Model: AD50		Date: 15-Feb-98	No: 1
Modified Article: Bushing for Development Unit		Prepared by: E.Fukuyama	
From: QAC Field Information Dept.			
Reason for Modification:	<input checked="" type="checkbox"/> Parts catalog correction <input type="checkbox"/> Vendor change <input type="checkbox"/> To meet standards <input type="checkbox"/> To facilitate assembly <input type="checkbox"/> To improve reliability () <input type="checkbox"/> Part standardization <input type="checkbox"/> Other

Model: AD50		Date: 30-Apr-98	No: 2
Modified Article: Duplex Guide Mylar		Prepared by: A. Sasaki	
From: QAC Field Information Dept.			
Reason for Modification:	<input checked="" type="checkbox"/> Parts catalog correction <input type="checkbox"/> Vendor change <input type="checkbox"/> To meet standards <input type="checkbox"/> To facilitate assembly <input type="checkbox"/> To improve reliability () <input type="checkbox"/> Part standardization <input type="checkbox"/> Other

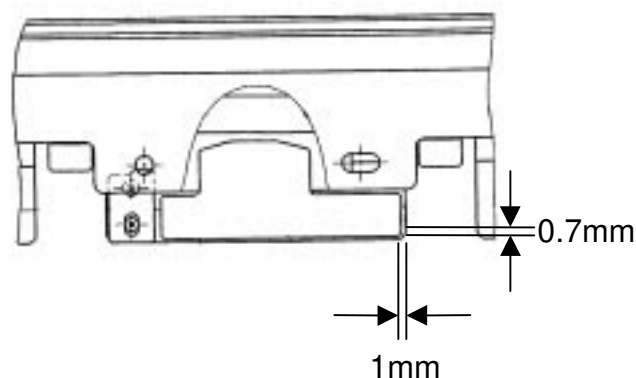
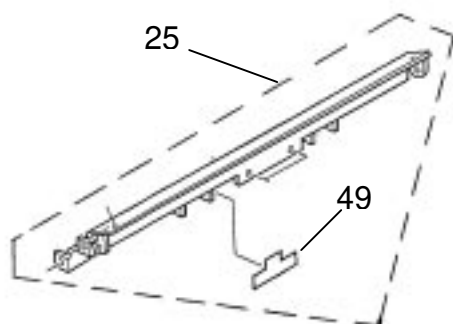
Please add the following part to the parts catalog.

Please refer to the illustration below for the attachment position of the mylar.

Old part number	New part number	Description	Qty	Int	Page	Index	Note
	A1344670	Duplex Guide Mylar	1		65	49	New Index

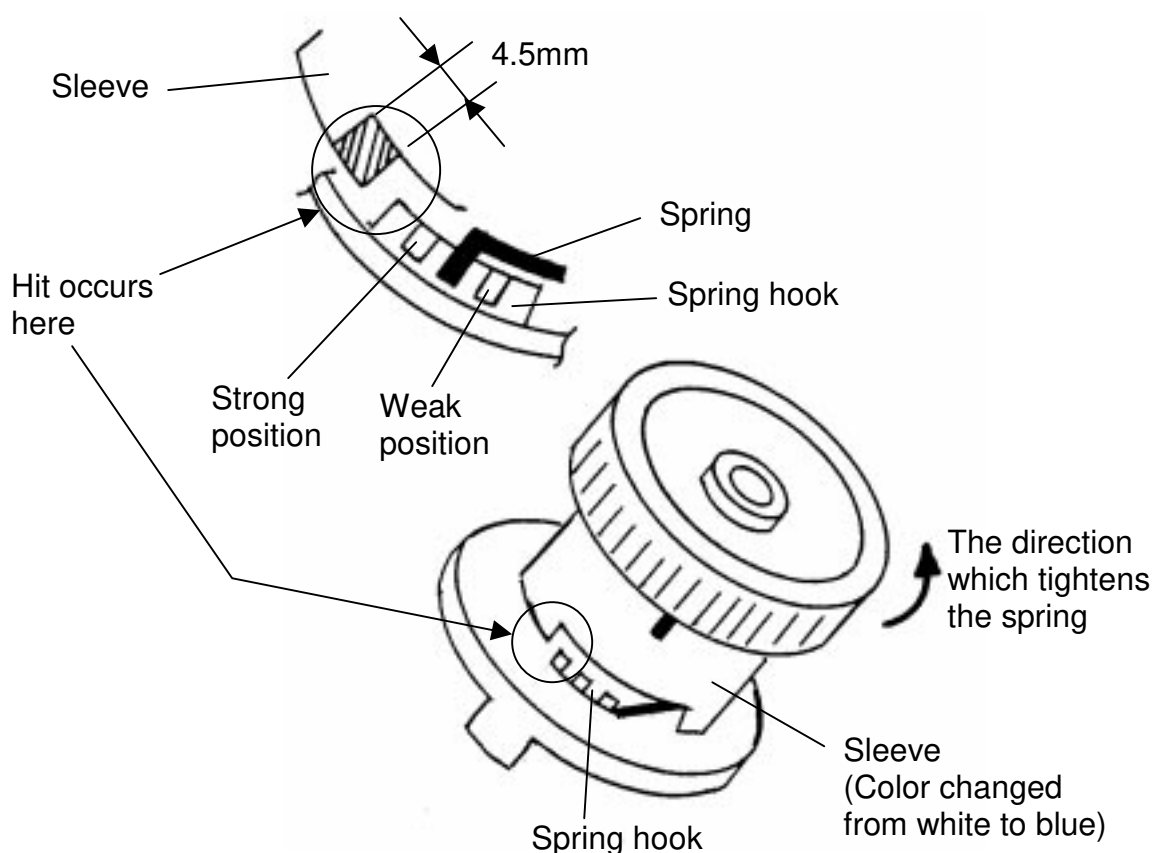
To reduce no-feed jams in the duplex unit caused by insufficient pressure from the bottom plate, the shape of the spring clutch has been changed. To distinguish between the old and new clutches, the color of the sleeve has been changed from white to blue.

The insufficient pressure occurs when the clutch turns in the direction which tightens the spring. This is because when the sleeve hits the spring hook, the spring cannot turn completely, so the bottom plate cannot be lifted up to the highest position.

To prevent the sleeve from hitting the spring hook, a 4.5-mm wide section of the sleeve has been cut away as shown.

Old part number	New part number	Description	Qty	Int	Page	Index	Note
AB040015	AB040017	Spring Clutch – Tray Bottom Plate	1	X/O	65	35

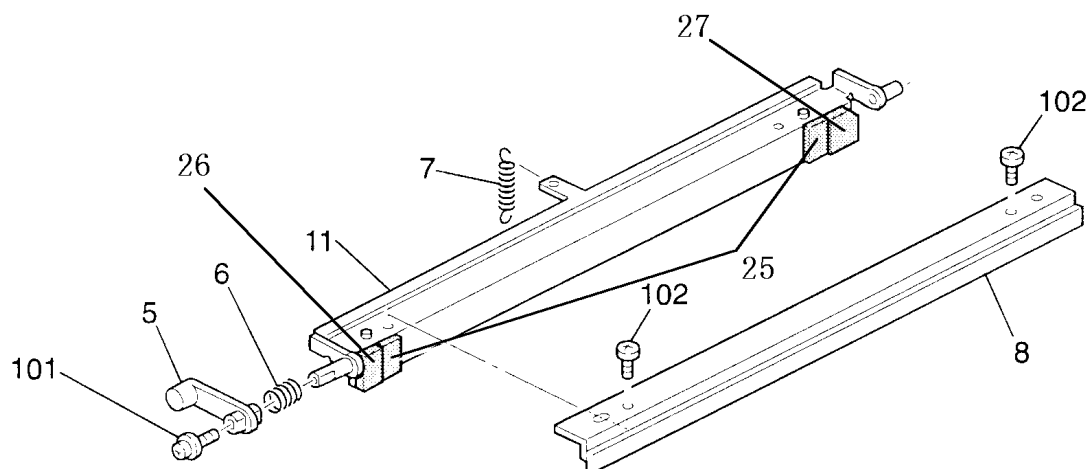
The following parts have been added as service parts.

Please add them to your parts catalog.

Old part Number	New part Number	Description	Qty	Int	Page	Index	Note
	AA151809	Rear Seal	2		51	25	New Index
	AA151807	Shield:Blade:Front	1		51	26	New Index
	AA151782	Shield:Blade:Rear	1		51	27	New Index

5. TRAY PAPER FEED (A217)

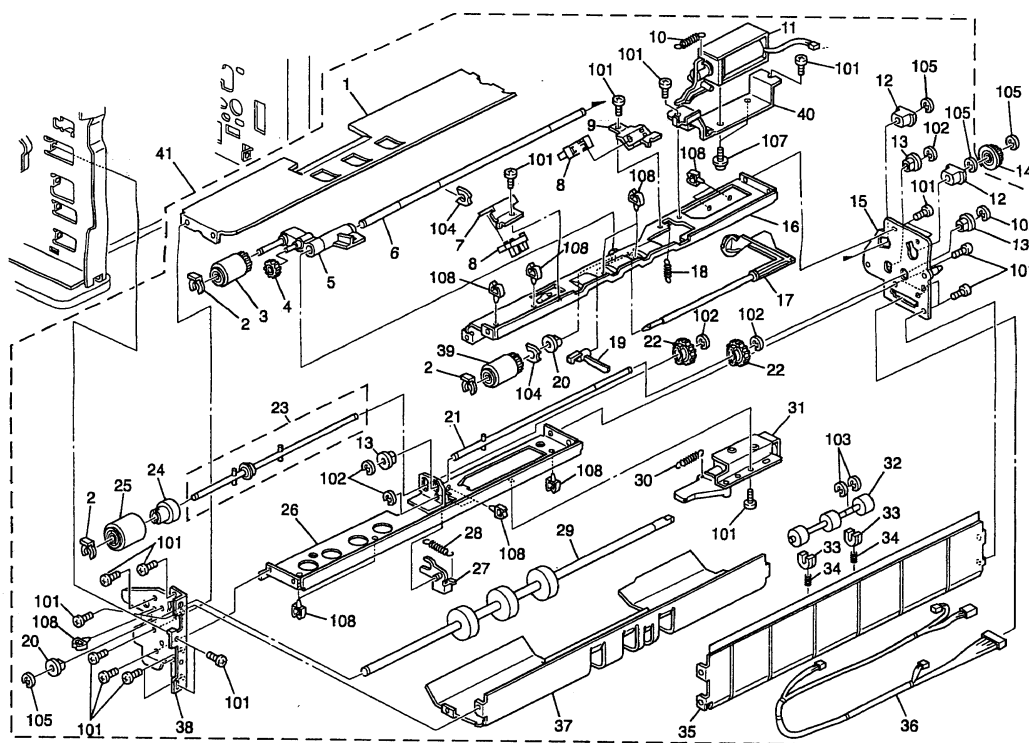
The following parts have been added. Please correct your parts catalog.

Old part number	New part number	Description	Q'ty	Int	Page	Index	Note
	A1342750	Paper Feed Unit – Lower	1		19	41

14.OPTICS SECTION 2 (A217)

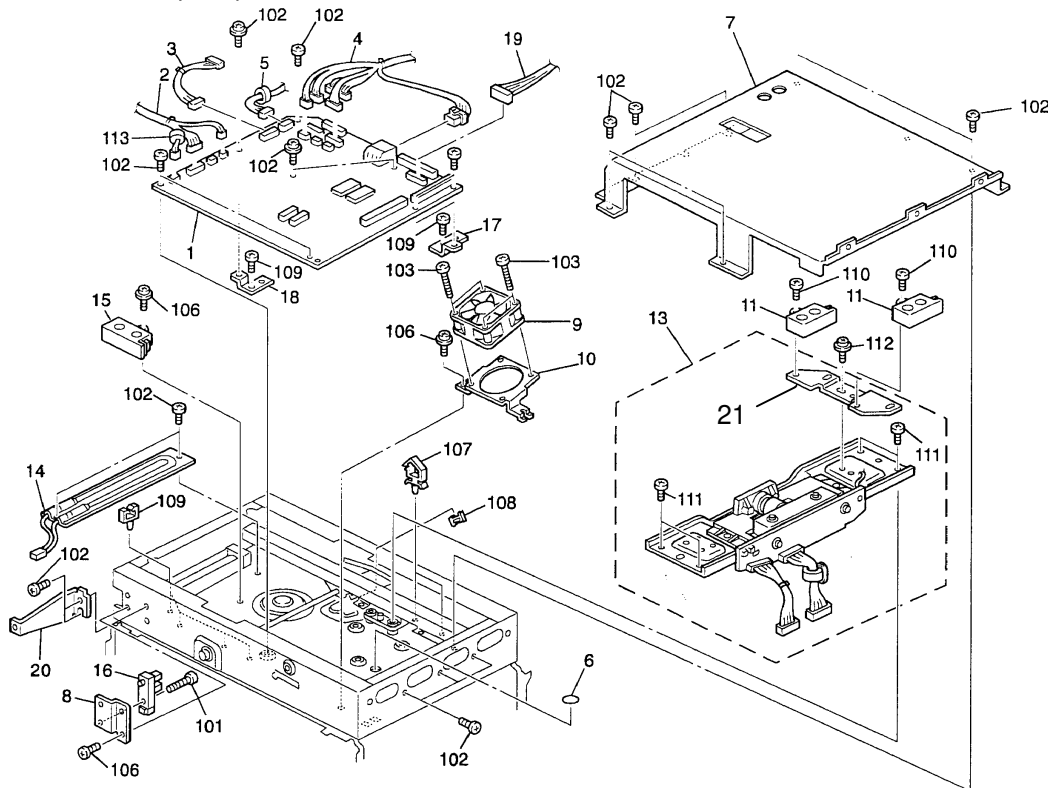
The following part has been registered as a service part.
Please add this to your parts catalog.

Part number	Description	Q'ty	Page	Index
A130 1828	Bracket – Original Size Sensor	1	37	21

14.OPTICS SECTION 2 (A217)

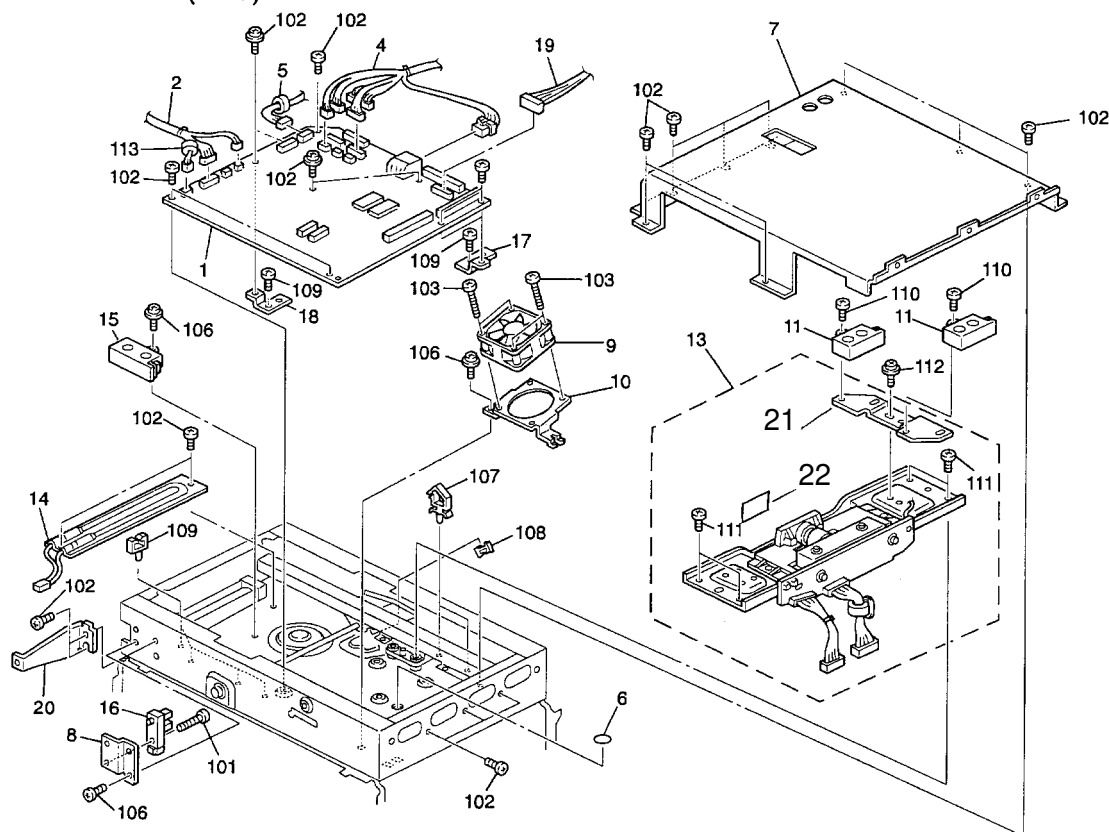
The following part has been added as a service part.
Please add this to your parts catalog.

Old part number	New part number	Description	Q'ty	Int	Page	Index	Note
-	AA011041	Light Filter-G530/G533	1	-	37	22
